SUBJECT: RELAXATION OF THE REQUIREMENTS OF ORDER EA-03-009, DATED FEBRUARY 11, 2003, REGARDING EXAMINATION COVERAGE FOR REACTOR PRESSURE VESSEL HEAD PENETRATION NOZZLES FOR BEAVER VALLEY POWER STATION, UNIT NO. 2 (TAC NO. MC0237)

SAFETY EVALUATION BY THE OFFICE OF NUCLEAR REACTOR REGULATION

ORDER EA-03-009 RELAXATION REQUEST

BEAVER VALLEY POWER STATION, UNIT NO. 2

Figure 1: BVPS Unit 2 CRDM Penetration Nozzle Configuration
Outermost Penetrations

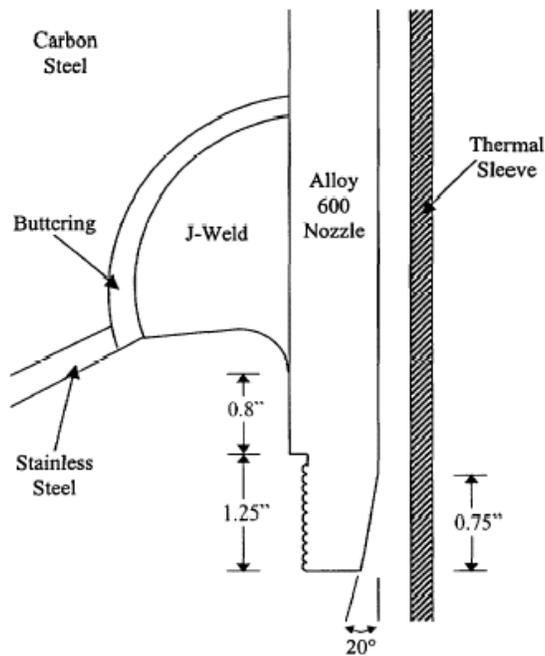
In its supplemental letter dated December 19, 2003, the licensee provided the field results showing the actual inspection distances achieved below the J-groove welds during its 10th refueling outage required by Section IV, paragraph C.2(b) of the Order. The NRC staff notes that these inspections were not required to be performed since a BMV had been accomplished that same outage and BVPS-2 is a moderate susceptibility plant. A drawing of a BVPS-2 CRDM penetration is shown below with the field measurements taken during the BVPS-2 10th refueling outage tabulated below. The drawing shows that the most limiting distance is on the downhill side of the J-groove weld where the nozzle distance is the shortest.

Figure 6-15 Through-Wall Axial Flaws Located in the 38.7 Degrees Row of Penetrations, Uphill Side - Crack Growth

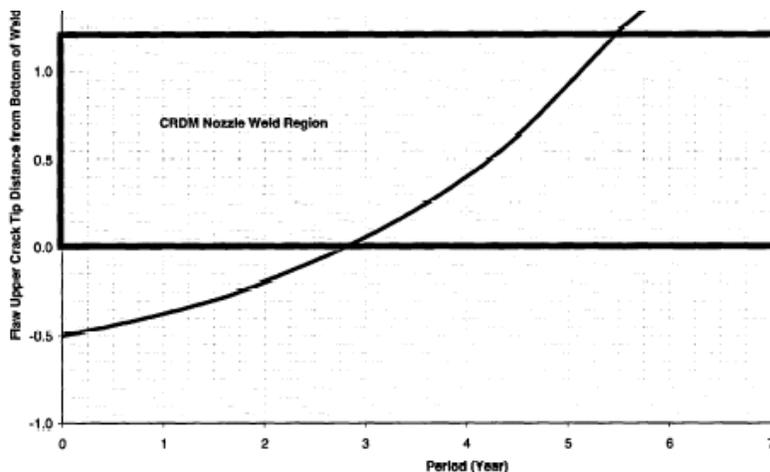
The flaw tolerance charts and the plant-specific hoop stress distribution charts provided by the licensee in WCAP-16144-P, Rev. 0, indicate that the licensee will be able to operate 6.1 EFY without an existing crack in the uninspected region propagating to the bottom of the J-groove welds, provided the minimum inspection distances below the weld are consistently achieved during the course of subsequent inspections.

The NRC staff notes that the stated EFY of permitted operation in the table above is predicated on achievement of the minimum inspection distances below the weld as determined by the licensee's plant-specific analysis. The licensee has justified operation for the operating period specified under Section IV, paragraph C.(2) for a moderate susceptibility plant. The NRC staff concludes that the licensee may claim credit for satisfying the requirement under Section IV, paragraph C.(2)(b) per the Order, because the alternative performed is supported by the crack-growth evaluation. Furthermore, the NRC staff concludes that the licensee must perform a BMV examination per Section IV, paragraph C.(2)(a) during the BVPS-2 11th refueling outage in order to comply with the testing frequency requirements of the Order. The licensee stated that for the BVPS-2 12th refueling outage, the projected susceptibility is high. At that time, the NRC staff concludes that the testing frequency of Section IV, paragraph C.(1) shall apply and that the examinations under Section IV, paragraphs C.(2)(a) and (b) will be performed every refueling outage.

If the NRC staff finds that the crack-growth formula in industry report MRP-55 is unacceptable, the licensee shall revise its analysis that justifies relaxation of the Order within 30 days after the NRC informs the licensee of an NRC-approved crack-growth formula. If the licensee's revised analysis shows that the crack-growth acceptance criteria are exceeded prior to the end of the current operating cycle, this relaxation is rescinded and the licensee shall, within 72 hours, submit to the NRC written justification for continued operation. If the revised analysis shows that the crack-growth acceptance criteria are exceeded during the subsequent operating cycle, the licensee shall, within 30 days, submit the revised analysis for NRC review. If the revised analysis shows that the crack-growth acceptance criteria are not exceeded during either the current operating cycle or the subsequent operating cycle, the licensee shall, within 30 days, submit a letter to the NRC confirming that its analysis has been revised. Any future crack-growth analyses performed for this and future cycles for RPV head penetrations must be based on an acceptable crack-growth rate formula.
